**Subject: Homestead North at Sterling Ranch Phase I Preliminary Plan, Review #3 (SP-20-008)**

**Homestead North at Sterling Ranch Phase I Preliminary Plan Review**

**Homestead North at Sterling Ranch - Phase I**

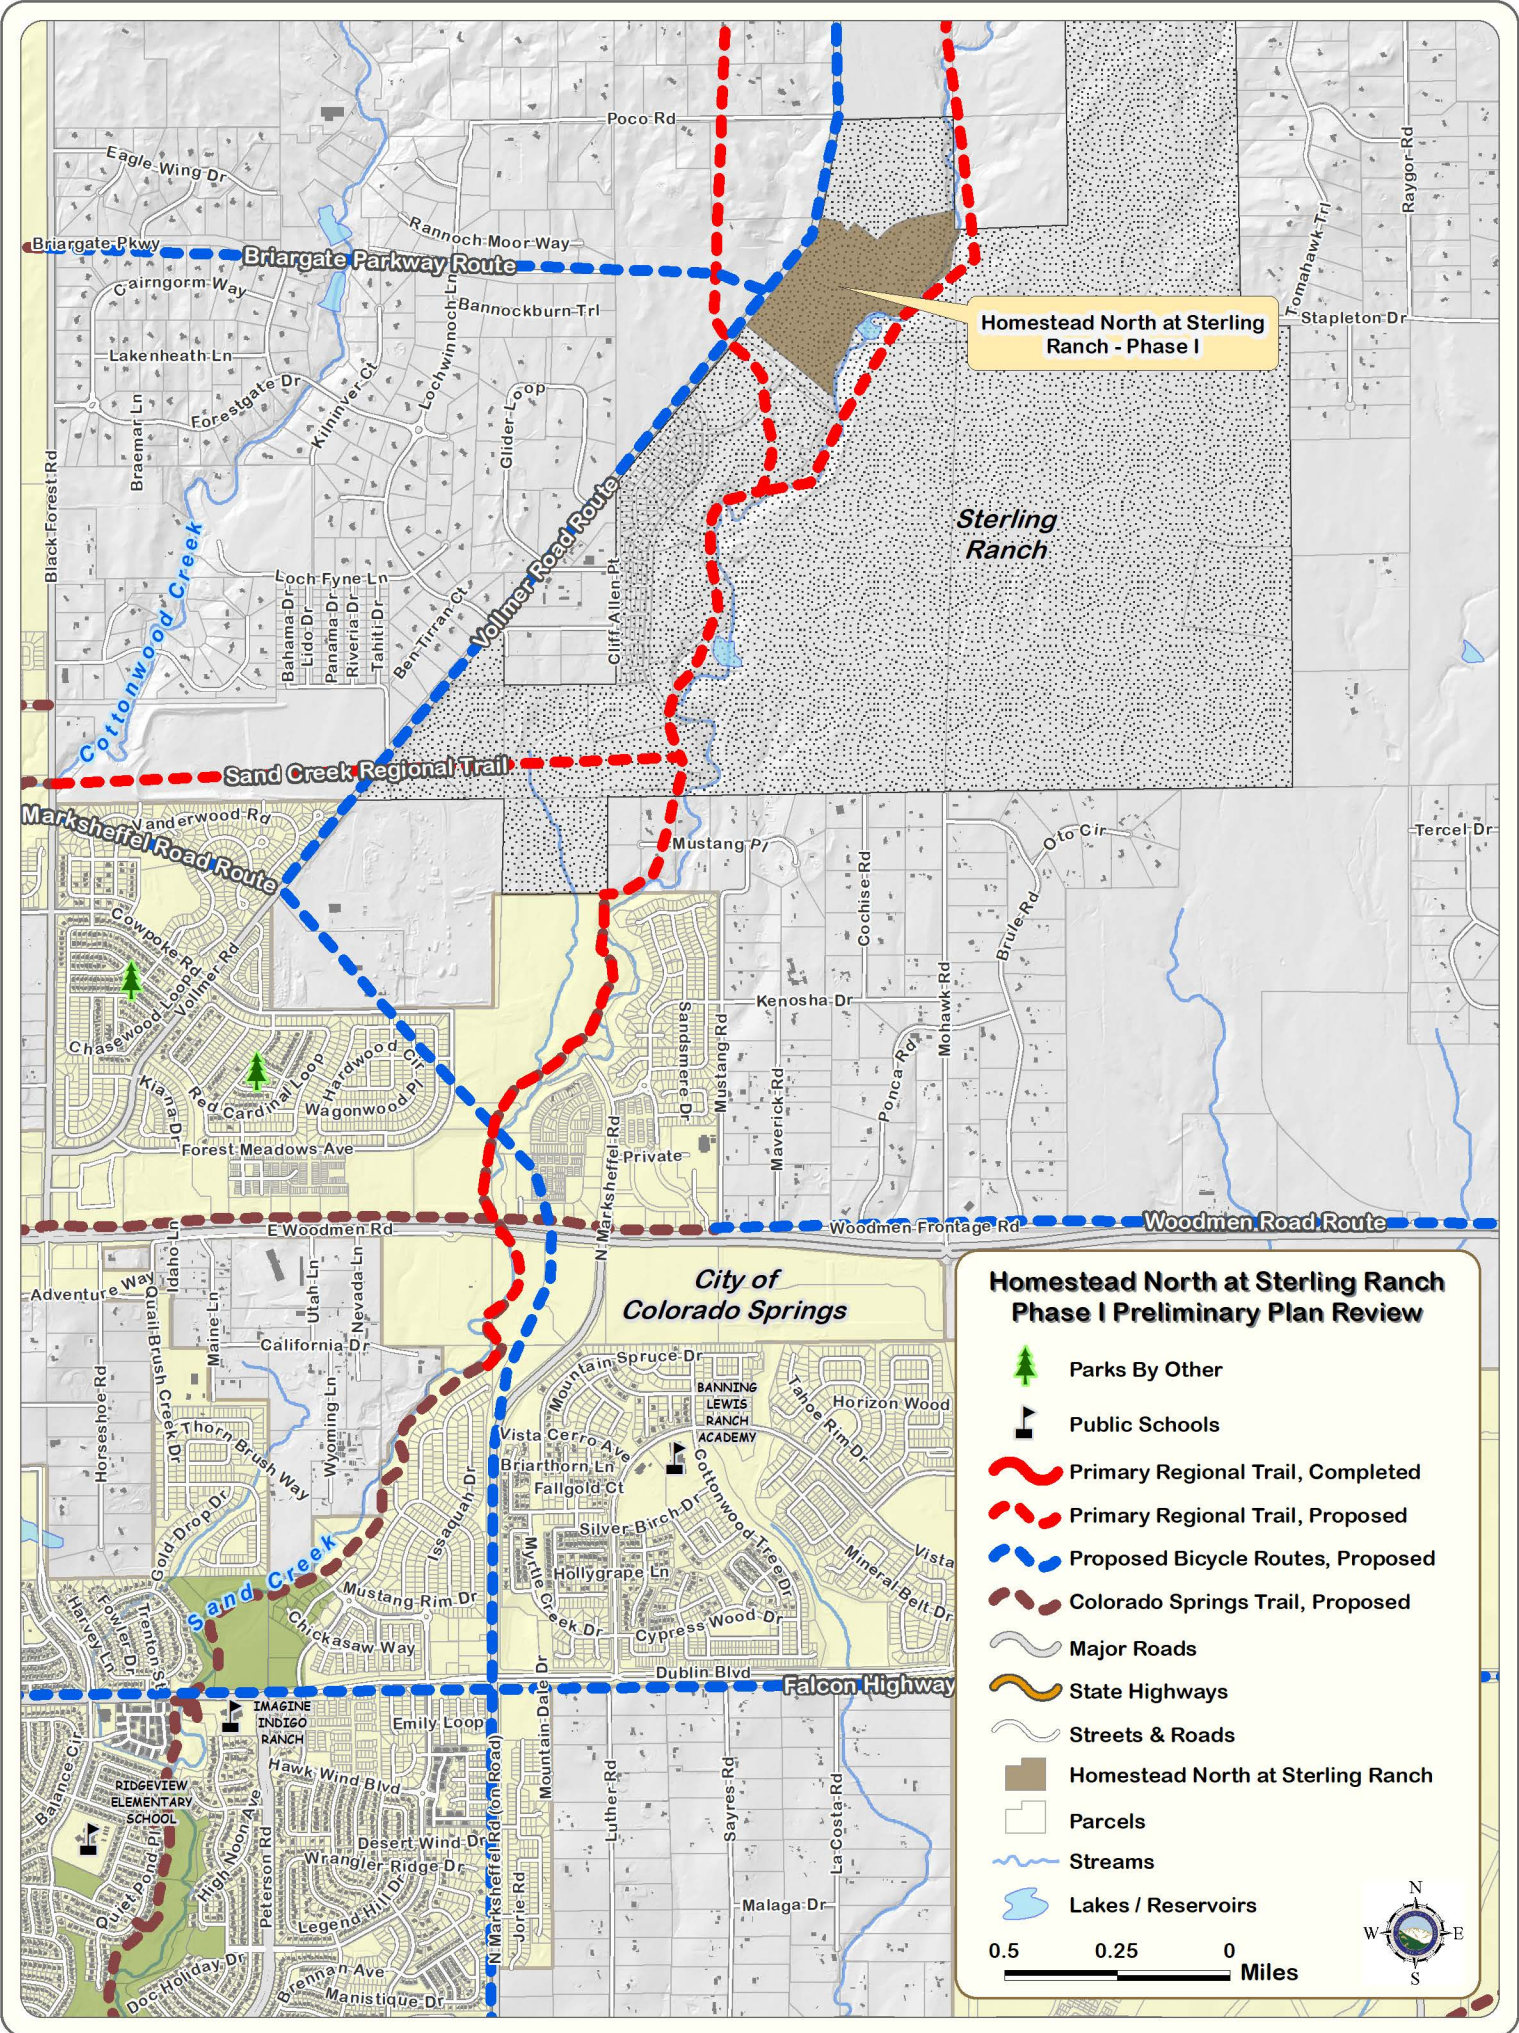
The Park Operations Division of the Community Services Department has reviewed the Homestead North at Sterling Ranch Phase I Preliminary Plan, Review #3, development application and has the following additional comments of behalf of El Paso County Parks. **EPC Parks staff continues to note the absence of the Sand Creek Regional Trail from the Preliminary Plan cover sheet and all additional sheets included with the Preliminary Plan. While a trail or road is shown in the Preliminary Plans, it is labeled as a "15' Maintenance Trail" and does not continue south of Briargate Parkway. The General Notes section does mention that trails labeled as "County Regional Trail" will be maintained by El Paso County, but none exist on this iteration of the Preliminary Plan.**

***"Staff questions the removal of the Sand Creek Regional Trail alignment and labeling from the Preliminary Plan, particularly on the cover page and Site Plans. The included utility and grading plans do show what appears to be the Sand Creek Regional Trail, but there are no labels indicating it as so. As noted in the following comments and recommendations, as endorsed by the Park Advisory Board on January 13, 2021, EPC Parks is requesting a 25' trail easement for the construction and maintenance of the Sand Creek Regional Trail. Staff also requests clarification as to the number of neighborhood parks proposed for Homestead North. The current Letter of Intent mentions one 0.87-acre park located in Tract B, but also indicates a park in Tract F. The location of the Tract F park is not indicated in the Preliminary Plan. Furthermore, staff acknowledges the increase in Preliminary Plan acreage from 60.6 acres to 77.7 acres due to the inclusion of the eastern and southern extensions of Briargate Parkway and Sterling Ranch Road, respectively."***

*The proposed Sand Creek Regional Trail is depicted in the Preliminary Plan, and labeled as “10’ County Gravel Trail,” although when constructed, the trail will follow EPC Parks Tier I Trail standards with an 8’ wide crusher fine trail surface with 2’ natural shoulders. The Preliminary Plan also shows concrete sidewalks/trails located adjacent Vollmer Road and the future Briargate Parkway extension. These non-County trails will allow for direct off-street connectivity to the Sand Creek Regional Trail for the residents and visitors of Sterling Ranch.*

*Due to the location of the Sand Creek Primary Regional Trail within the Homestead North at Sterling Ranch Phase I development, El Paso County Parks staff recommends that the applicant designate, provide, and dedicate to El Paso County a 25-foot trail easement that allows for the construction, maintenance, and public access of the regional trail. Furthermore, staff recommends fees in lieu of land dedication for regional and urban park purposes.*

*The Park Advisory Board recommends that the Planning Commission and the Board of County Commissioners include the following conditions when considering and/or approving the Homestead North at Sterling Ranch Phase I Preliminary Plan: (1) designate and provide to El Paso County a 25-foot trail easement through Homestead North at Sterling Ranch, within Tract F, that allows for construction, maintenance, and public access of the Sand Creek Primary Regional Trail, and dedicate the easement to El Paso County prior to the recording of the forthcoming final plat(s); 2) include descriptions, drawings, and locations of the two neighborhood parks in the Letter of Intent and Preliminary Plans, respectively; 3) fees in lieu of land dedication for regional park purposes in the amount of \$68,649 and urban park fees in the amount of \$43,365 will be required upon recording of the forthcoming final plat(s). A Park Lands Agreement may be an acceptable alternative to urban park fees, provided the agreement is approved by the County and executed prior to recording the forthcoming final plat(s).”*
